**ADDENDUM FOUR
AVONDALE YOUTH AND FAMILY DEVELOPMENT CENTER
SITE IMPROVEMENTS
CONTRACT NO. Y-15-008-203
CITY OF CHATTANOOGA, TENNESSEE**

The following changes shall be made to the Contract Documents, Specifications, and Drawings:

SHEET: CS 060

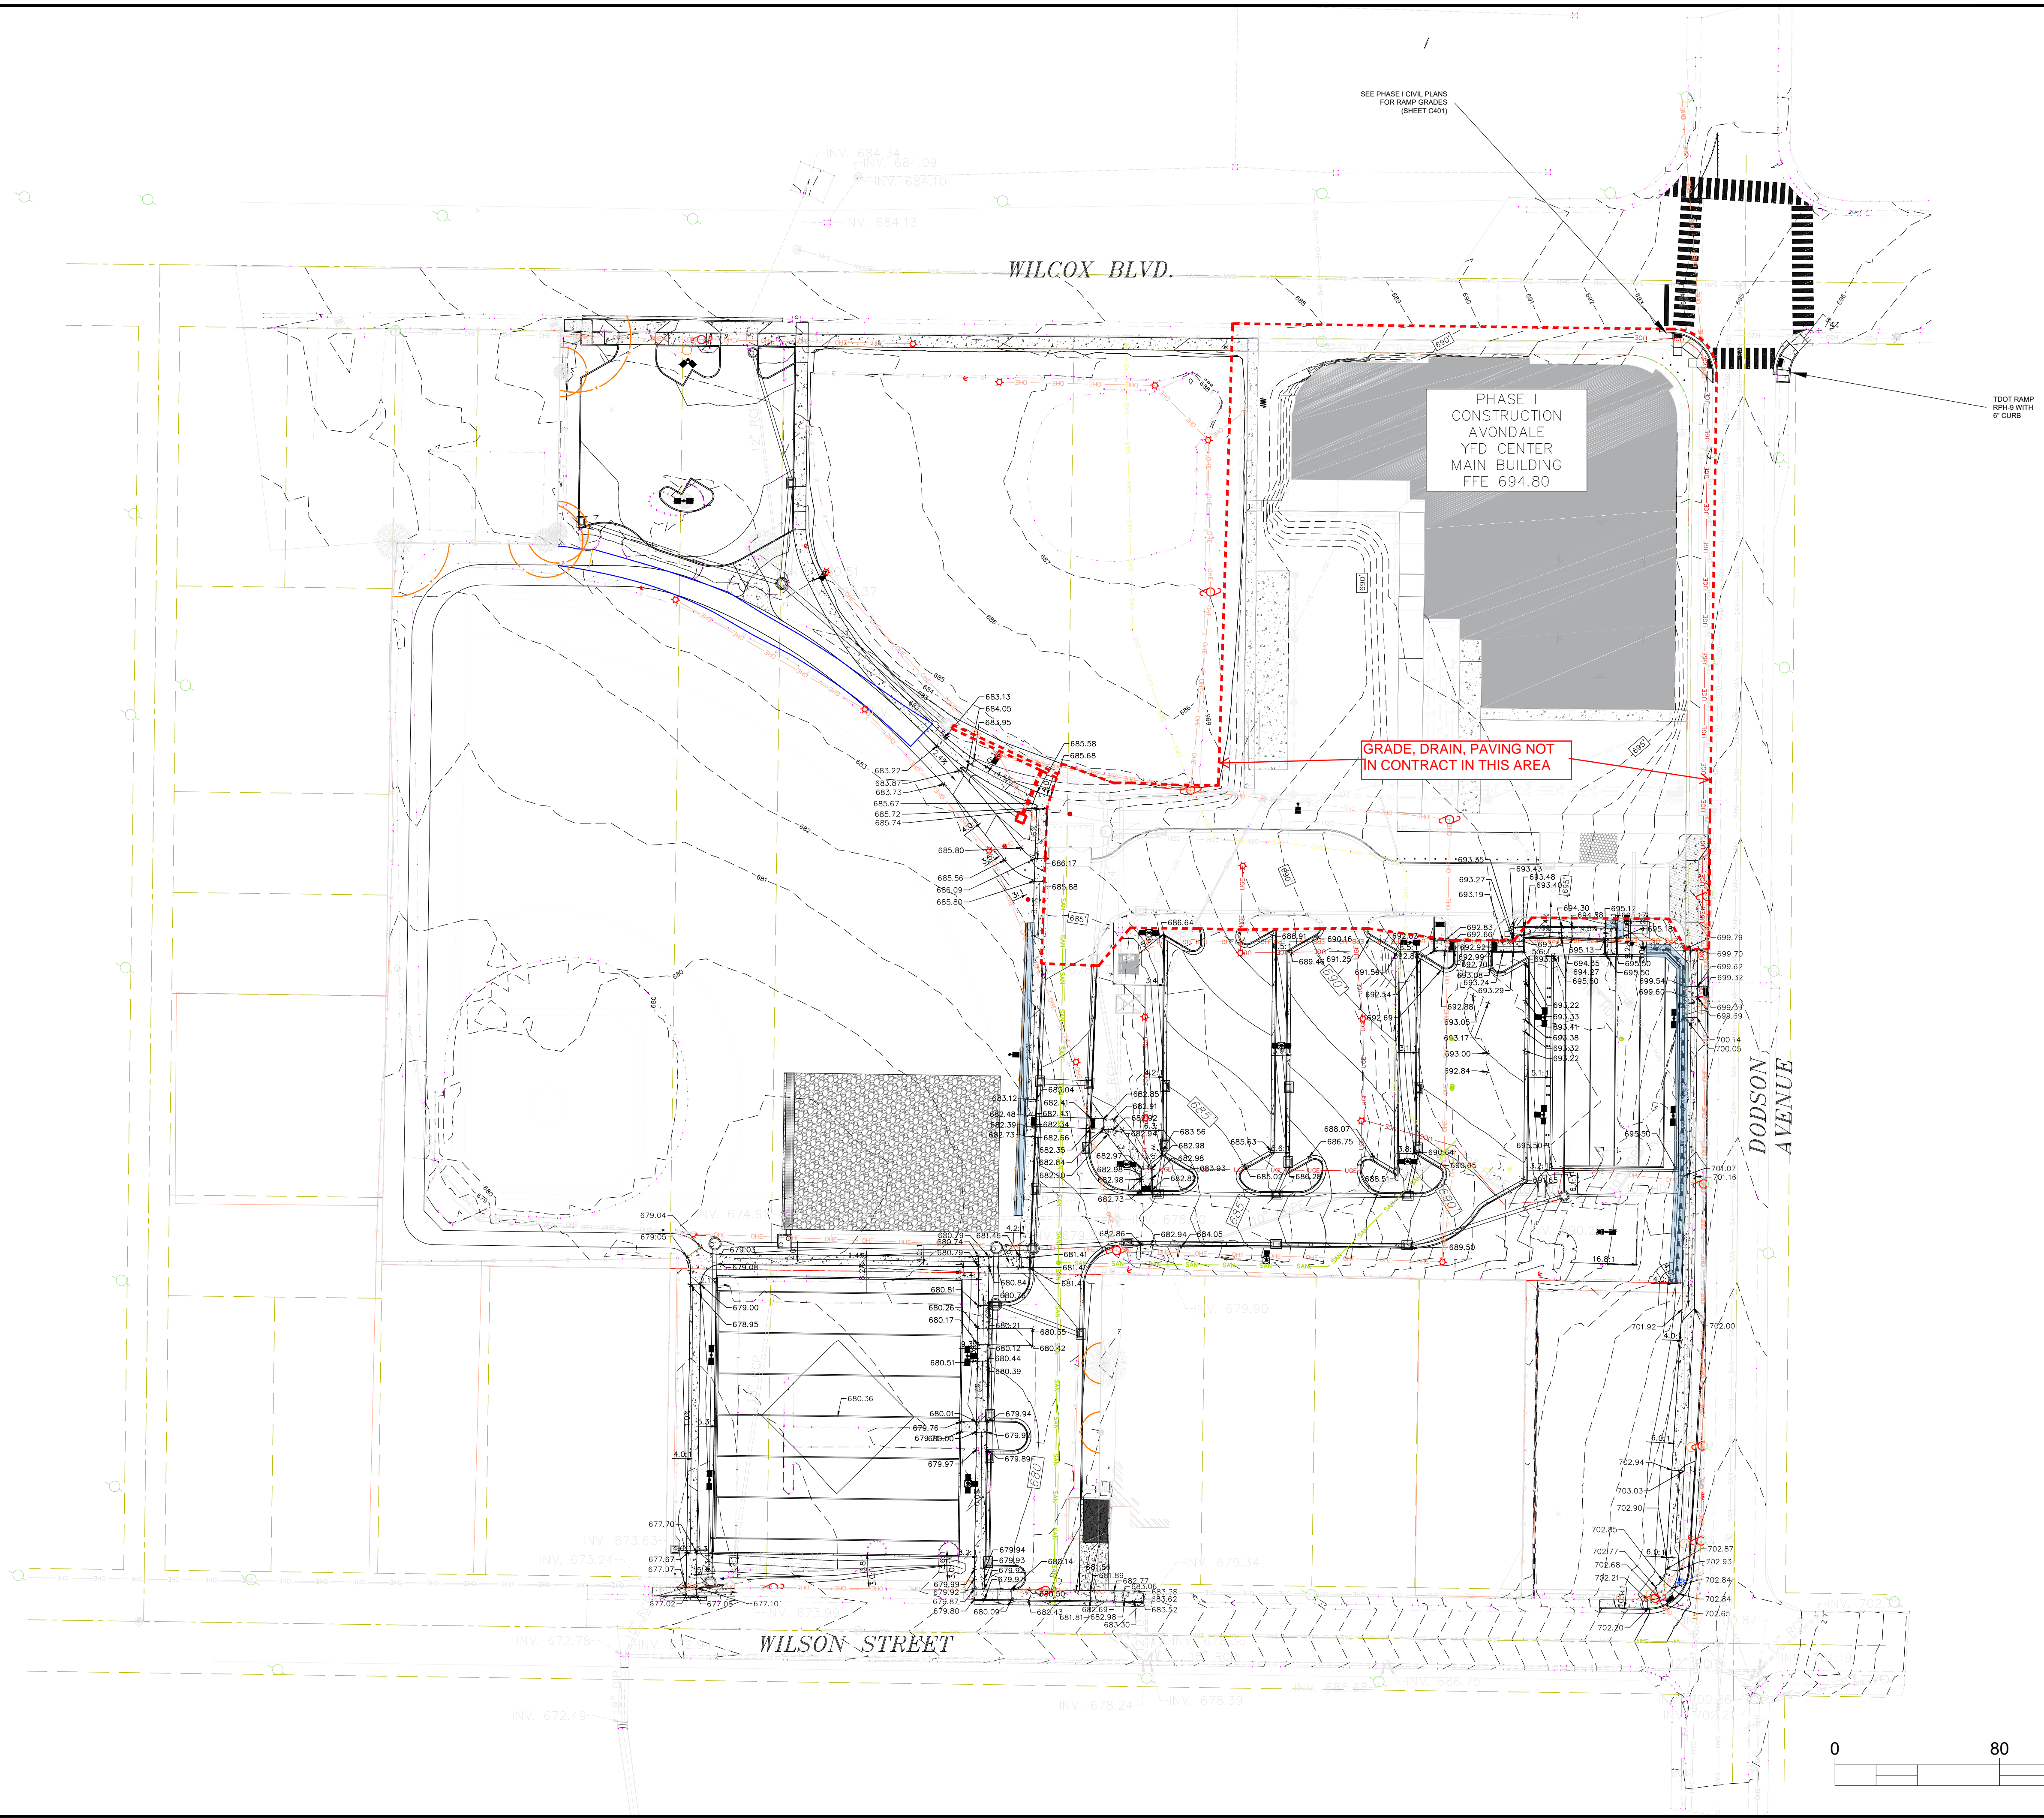
Q: Grading plan sheets CS060 and CS080 do not have clear existing contour lines, making it difficult to calculate quantities. Can an existing site plan with contour lines be available?

A: CS060 and CS080 have been regenerated with more legible contour lines.
